PROJECT REVIEW REPORT

Project ID	4144
Project Name	CHITETEOZ MBAULA PROJECT – MALAWI
Review Type	Registration and Verification
Verification Period	01/08/2021 – 16/02/2023
Program(s)	VCS Program
Project Proponent	CO2Logic SA
Methodology	VMR0006, “Methodology for Installation of High Efficiency Firewood Cookstoves”, Version 1.1
VVB	Carbon Check (India) Private Ltd.
Assessment Criteria	VCS Standard, v4.4
Date of First Issue	12 December 2023
Date of Second Issue	25 March 2024
Date of Third Issue	01 August 2024

Review Conclusion	APPROVED
Date of Final Issue	21 October 2024

The page then opens on the 31% efficiency stated by the CCA:

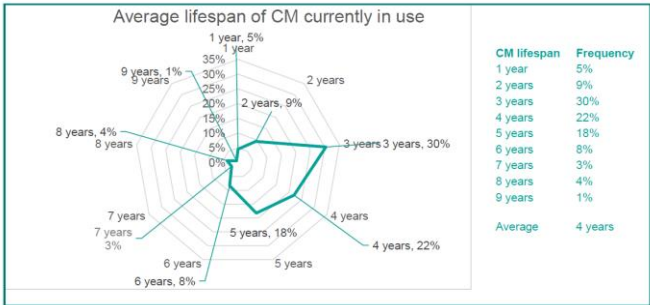
- 1) The link provided does not show the mentioned value.
- 2) The source applied is not aligned with the methodology requirements to establish the efficiency of the project cookstove.
- 3) The VVB did not provide an assessment of the efficiency value used for the project cookstove.

1. The VVB must provide a detailed assessment of the validation activities performed to ensure that the project efficiency is conservatively determined.
2. The VVB must provide an assessment on how the efficiency value stated is aligned with the methodology requirements.

- 2) With regards to stove efficiency, the project makes use of equations (3) and (5). $\eta_{new,ij}$ is therefore determined through η_p , the efficiency of the project stove at the start of project activity. In section 9.1 of VMR0006 v1.1, η_p source of data is

specified as “Manufacturer’s specifications”. The Chitetezo Mbaula being manufactured by different SPG’s the value from the Clean Cooking Alliance represents the best available value on that particular stove model and is in line with the methodology requirements to establish the efficiency of the project cookstove. <u>VVB response:</u> VVB has reviewed all the response provided by PP from 1 to 2 which is acceptable. 1. The Clean Cooking Alliance provides a range of 29% to 33%, for which the mean value of 31% was adopted by PP which is more conservative approach furthermore the detailed assessment has been provided in the JVR-VR under section 3.1, table 1 and section 3.4.2 table 2. 2. VVB has provided the assessment of efficiency on 31% which in line with requirement of the methodology of section 2 and point number 2 “Project stoves to be implemented shall have specified high-power thermal efficiency of at least 25%” and further validation team has confirmed the efficiency values through the Average value of WBT results publicly available in the Catalog of Clean Cookstoves: http://catalog.cleancookstoves.org/stove_details.html?stove_id=stove_VROU4NT see “Additional Details” and KPT test results provided by PP which deems appropriate and acceptable to validation team. 3. VVB has provided the detailed assessment of the efficiency value used that is 31% which is inline with

the requirement of the methodology under section 3.1, of table 1 and section 3.4.2 table 2. <u>Verra Response</u> The information of the ICS efficiency has been provided, as per the link under footnote 5 of the JPD-MR which shows that 2 tests have been performed to measure the IWA High Power Thermal Efficiency [%] during 2012, with an efficiency ranging from 29-33%. <u>Issue raised:</u> It remains unclear why, for the selection of the efficiency, the mean value has been adopted and not the most conservative one, also considering that the results are from a different manufacturer (i.e., Nkhoma Mountain Conservation). <u>Action Required:</u> The VVB must explain how the conservative principle from the VCS Standard ver. 4.5, section 2.2.1 has been considered when accounting for the efficiency of the project stoves.	
		Round 2 <u>VVB response</u> VVB evaluated the update JPD-MR and confirmed that the PP has now opted the efficiency of project stove as the lowest threshold i.e. 29% from the efficiency range of (29% to 33%). <u>Verra response</u> The revision of the efficiency to 29% has been accepted. <u>Issue raised:</u> However, the re-calculated values for the η_{new} under page 50 of the JVR-VR have not been revised. <u>Action required:</u>
